ADAMS BROADWELL JOSEPH & CARDOZO

February 22, 2021

Re: Comments on Draft Environmental Impact Report for Estrella Substation and Paso Robles Area Reinforcement Project

Figure 1: Average Wind Speeds for Paso Robles Airport⁵⁶

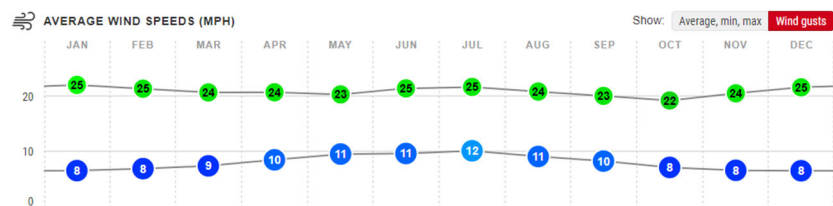
Windblown dust from Project disturbed soils is a particular concern at this site because high winds occur regularly during spring.⁵³ The DEIR fails as an informational document under CEQA for failing to include a wind rose for the Project area, which is known for high winds called the Santa Lucia winds.⁵⁴ Wind speed data for the Paso Robles Airport for the period September 2012 to December 2020 report an average wind speed of 9 mph.⁵⁵ Gusts up to 25 mph occur throughout the year. Figure 1.

In comparison, the DEIR’s construction emissions assumed an average wind speed of 3.2 m/s (7.2 mph).⁵⁷ The higher winds that occur at the Project site can raise significant amounts of dust, even when conventional dust control methods are used. If these winds occurred during grading, cut and fill, or soil movement, from bare graded soil surfaces (even if periodically wetted), significant amounts of PM10 and PM2.5 as well as silica dust would be released. As dust control is not required during nighttime hours when no active construction activity occurs, PM10 and PM2.5 emissions could be even higher than during active construction work. These emissions could result in public health impacts from Valley Fever spores (Comment 3), silica, and/or violations of PM10 and PM2.5 California Ambient Air Quality Standards (CAAQS) and National Ambient Air Quality Standards (NAAQS). The DEIR did not evaluate these potential impacts, thus failing as an informational document under CEQA.

Figure 2: Proximity of Homes to Reconductoring⁷⁴

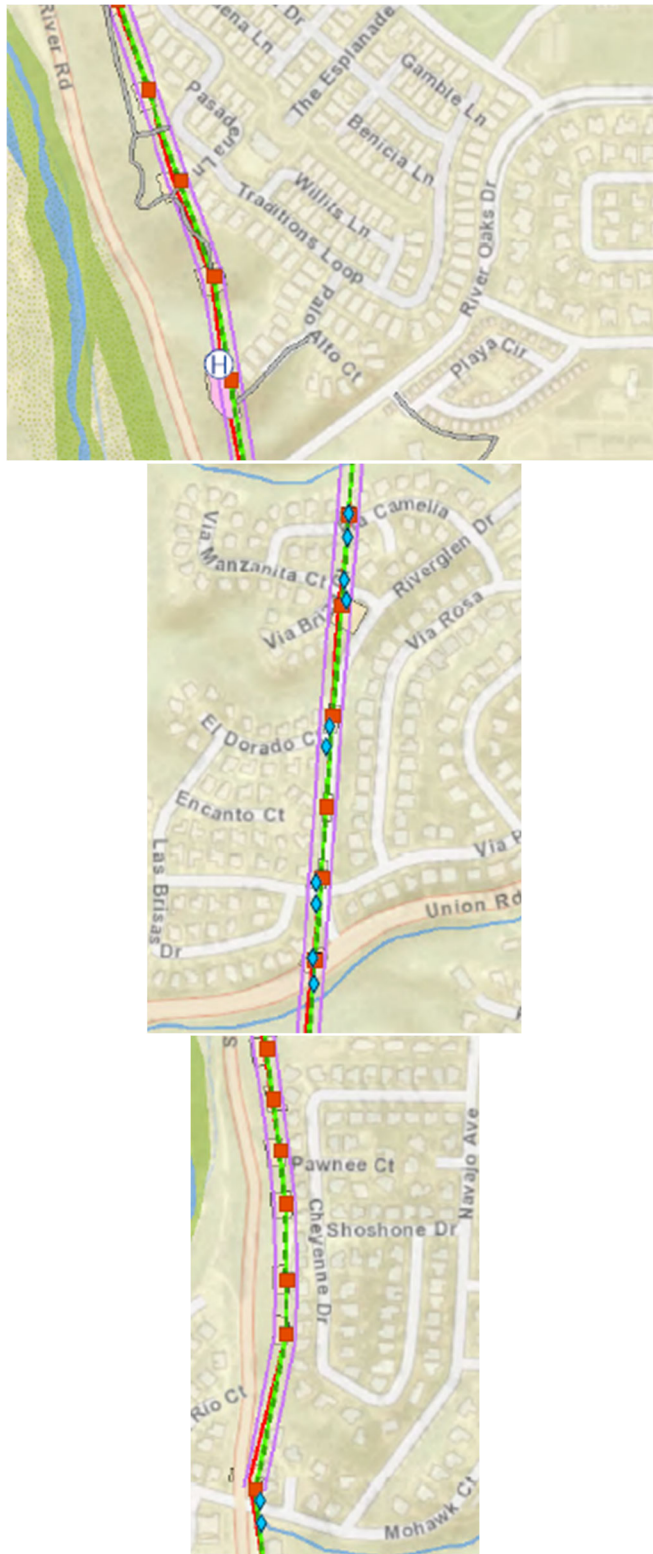
The PEA, for example, contains a list of 575 parcels within 300 feet of the Estrella Substation and the transmission line route.⁷² Elsewhere, the PEA contains a list of sensitive receptors in the vicinity of the Project, summarized here as Table 1. See also Figure 2. Of greatest concern is the entry of “numerous residences” closer than 50 feet. The occupants of these residences are at great risk of adverse health impacts from construction emissions.

Figure 3: Cancer Risk Isopleth Map, Scenario 1 (Tier 4 Final Engines)⁸³

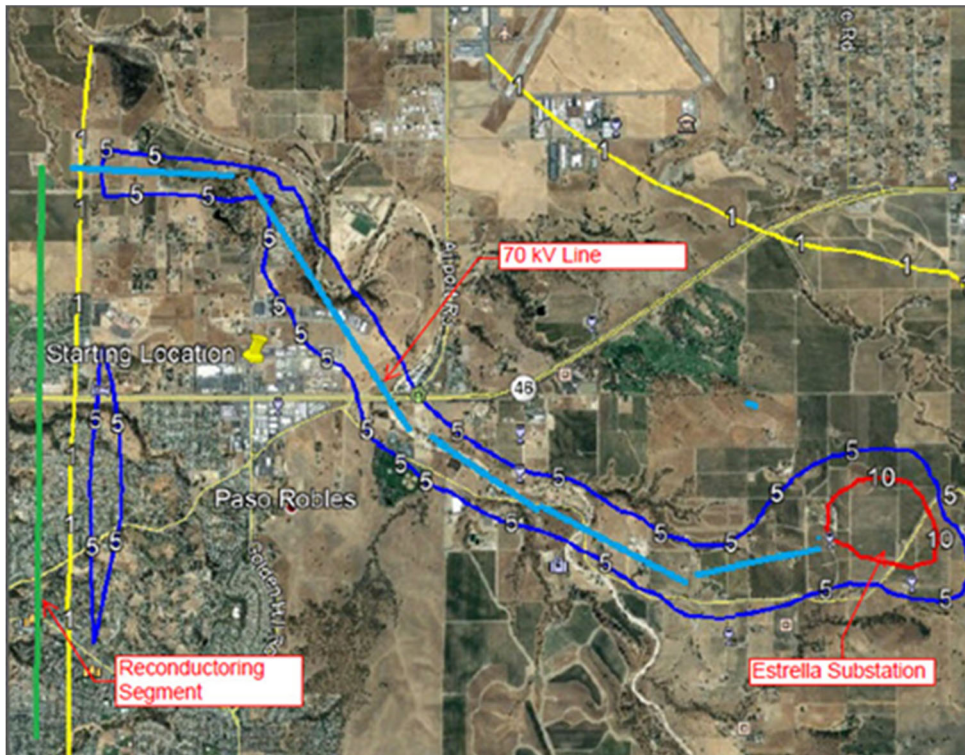
The cancer risk results for Scenario 1, which used the DEIR's DPM construction emissions based on 100% Tier 4 Final engines, are summarized in Figure 3.⁸² The cancer significance threshold is 10 cancer cases in one million exposed, or 10 in one million. The dark blue isopleth line corresponds to a cancer risk of 5 in one million, which is less than the cancer significance threshold.

Cancer risks only equal or exceed the significance threshold (red isopleth in lower right-hand corner of Figure 3 in the vicinity of the Estrella Substation). The PEA reports several residences within this isopleth. Table 1. Thus, if all Tier 4 Final engines are used for construction, cancer risks would only be significant in the vicinity of the Estrella Substation, requiring additional mitigation during construction of the Substation, such as mandating the use of biodiesel fuel in all construction equipment. However, the DEIR does not require all Tier 4 final engines or the use of biodiesel fuel.

Figure 4: Cancer Risk Isopleth Map, Scenario 2 (Tier 2 Engines)⁸⁴

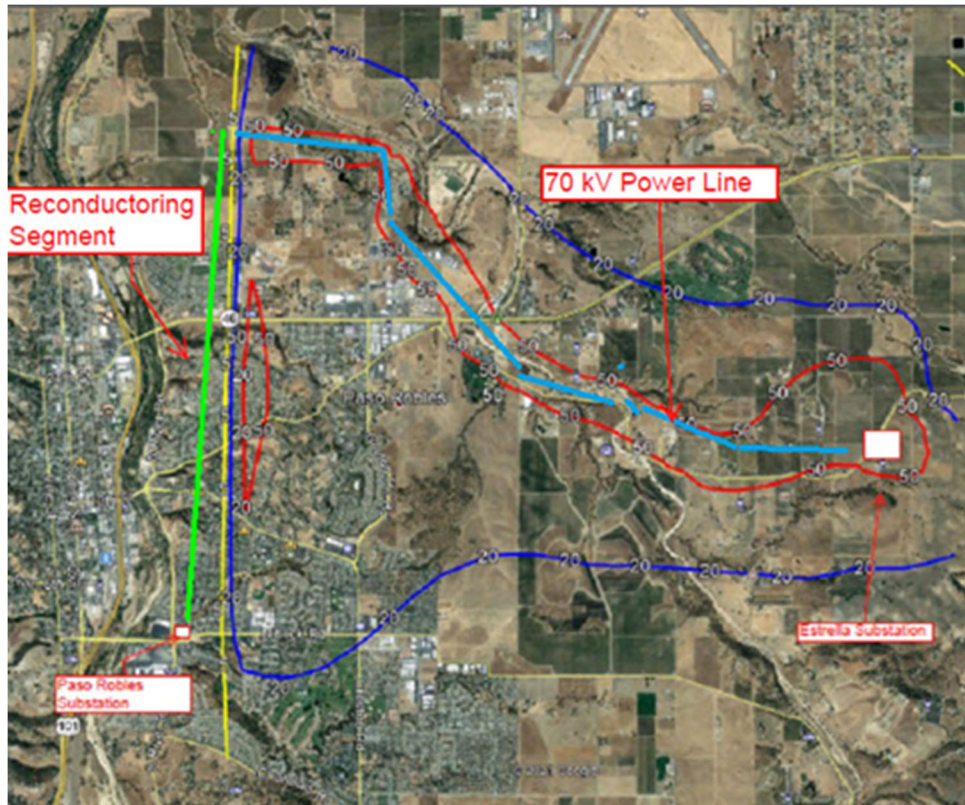
The cancer risk results for Scenario 2, which is based on the use of all Tier 2 construction equipment, as allowed by the DEIR (which only encourages an increase in Tier 3 engines, but does not require them), is summarized in Figure 4. The red isopleth line corresponds to a cancer risk of 50 in one million. The dark blue isopleth line corresponds to a cancer risk of 10 in one million. All sensitive receptors within these isopleths will experience significant cancer risks during construction.

The PEA identifies numerous sensitive receptors in the areas encompassed by these isopleths. Notably, it identifies residences “too numerous to pinpoint” within 50 feet of the reconductoring segment as well as a church, daycare center, golf course, park, and swim and tennis club, among others. Table 1.

Figure 5: Cancer Risk Isopleths for Scenario 2, Showing Homes East of the Reconductoring Segment⁸⁶

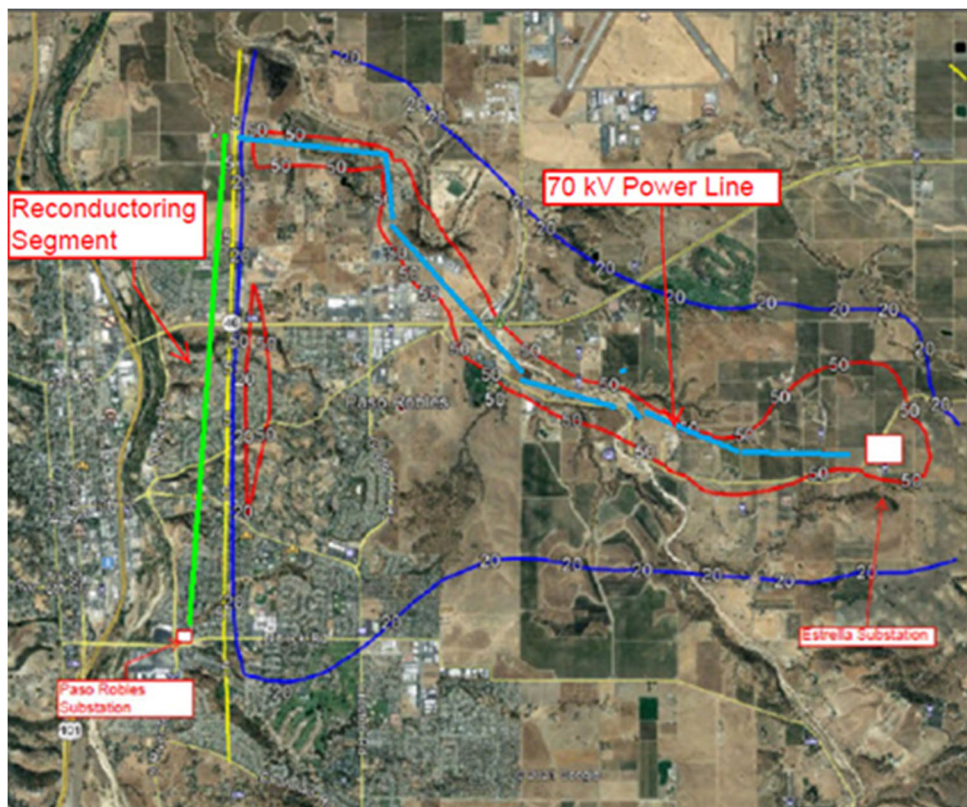
Figure 5 shows a close-up view of the area east of the reconductoring segment. This figure shows hundreds of homes within the 20 to 50 cancer cases per million isopleths. These are highly significant cancer risks, two to five times higher than the significance threshold of 10 in one million, requiring mitigation. These risks can be

mitigated by requiring the use of all Tier 4 construction equipment and diesel particulate traps (soot filters)⁸⁵.

Figure 6: Acute Health Isopleths for Scenario 1⁹⁰

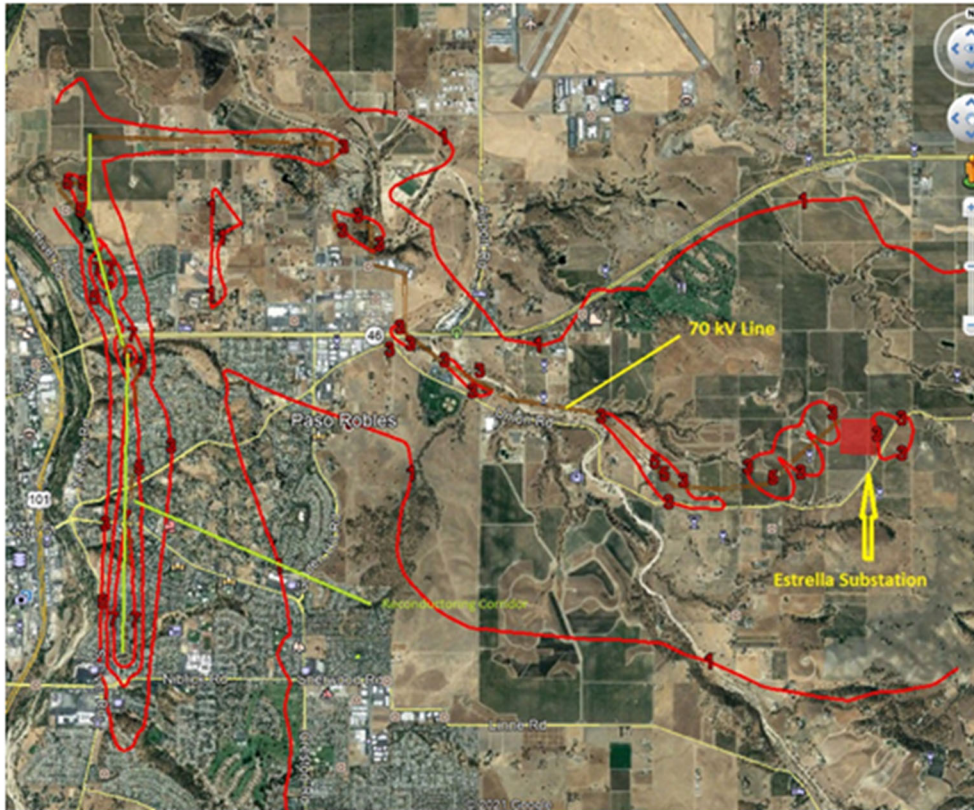
Figures 6 and 7 show isopleths for acute health impacts of DPM emissions during construction for Scenario 1, which assumed all Tier 4 final construction equipment and Scenario 2, which assumed all Tier 2 construction equipment. An acute hazard index greater than 1 is significant. Thus, the isopleths that show acute hazard indices greater than 1, such as those around the Estrella Substation, the 70 kV line, and the reconductoring segment are highly significant in both scenarios. Sensitive receptors in these locations will experience significant respiratory impacts.

Figure 9: Ambient Construction NOx Concentrations, Scenario 2⁹⁵

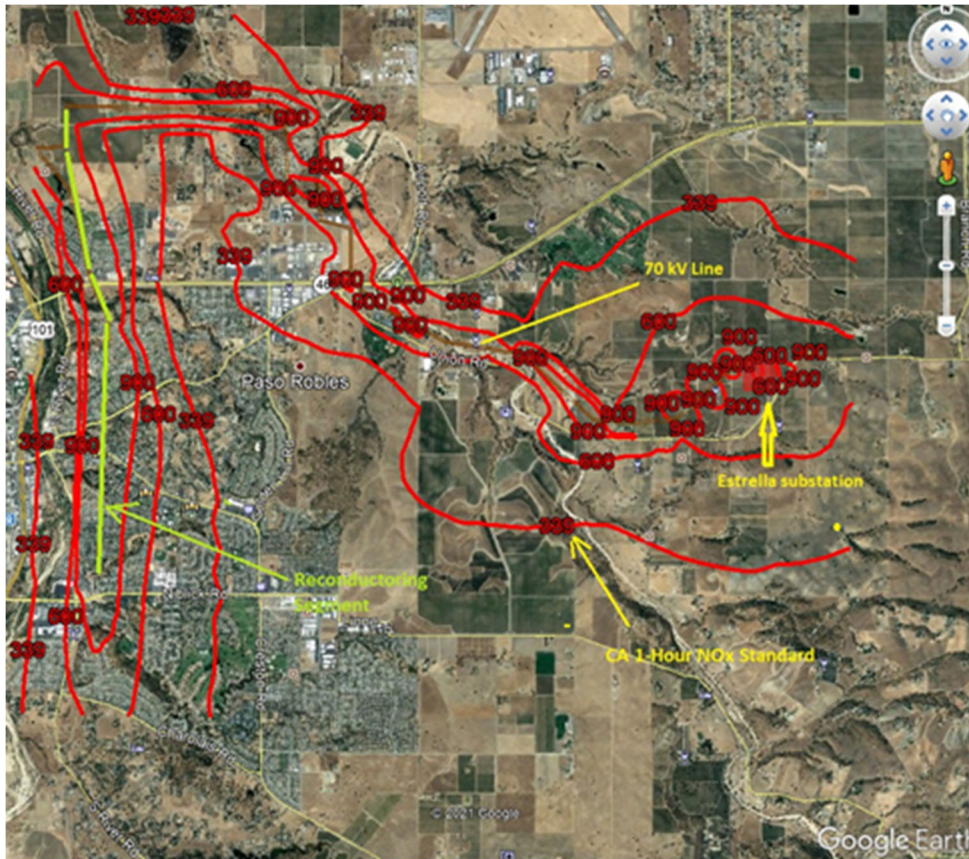
The result of modeling construction NO_x emissions assuming the use of all Tier 3 construction equipment are shown in Figure 9. This figure shows that the California 1-hour NO_x ambient air quality standard would be reach 900 ug/m³, nearly a factor 3 higher than the California 1-hour ambient air quality standard, in the vicinity of all Project components in locations with numerous sensitive receptors. This is both a significant air quality impact (violation of a state ambient air quality standard) and a significant health impact, as the state NO_x standard was set to protect public health.

**Figure 16: Segments of Transmission Line (in blue)
Proposed for Undergrounding (in pink)**

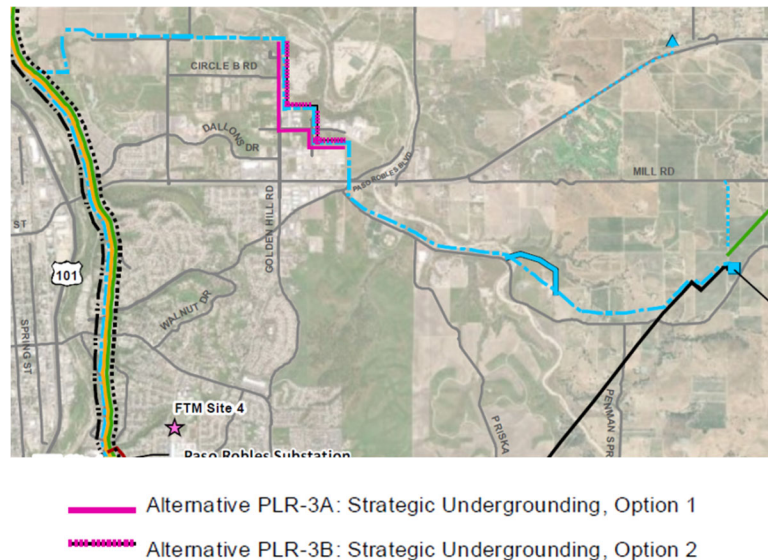
The DEIR included two alternatives to the aboveground transmission line, Alternative PLR-3A and PLR-3B to underground small portions of it, as shown in Figure 16. However, the DEIR failed to adopt either or explain why they were not adopted as they reduce otherwise highly significant aesthetic, public health, and biological impacts in the area as well as the risk of fire.

At a minimum, Alternative PLR-3, strategic undergrounding, should be adopted, as this segment of the transmission line passes through the Golden Hill Road area north of SR 46, which has the greatest potential for public health, aesthetic, biological, and other environmental impacts. Figure 16.

Figure 17: Reported Fire Incidents Triggered by Electrical Line Malfunctions, 2014–2017

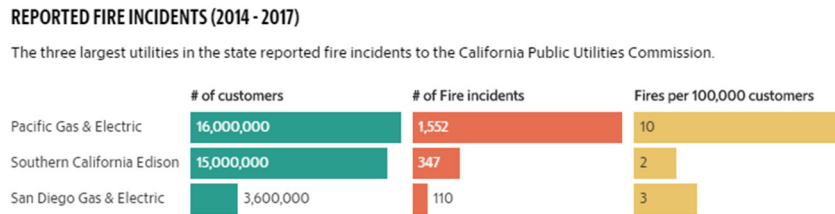
Most power outages are triggered by fires. Strong winds can topple trees or blow branches onto power lines, pulling them down and causing them to arc, sending sparks into dry vegetation. A voltage surge in a line can cause it to arc to a nearby tree, causing a fire. PG&E, for example, reported 1,554 fires caused by its equipment between June 10, 2014, and December 29, 2017, mostly from overhead conductors. Southern California Edison reported 347 fires in that same time. Electrical line malfunctions sparked most of the PG&E fires.³⁶⁰ Figure 17.
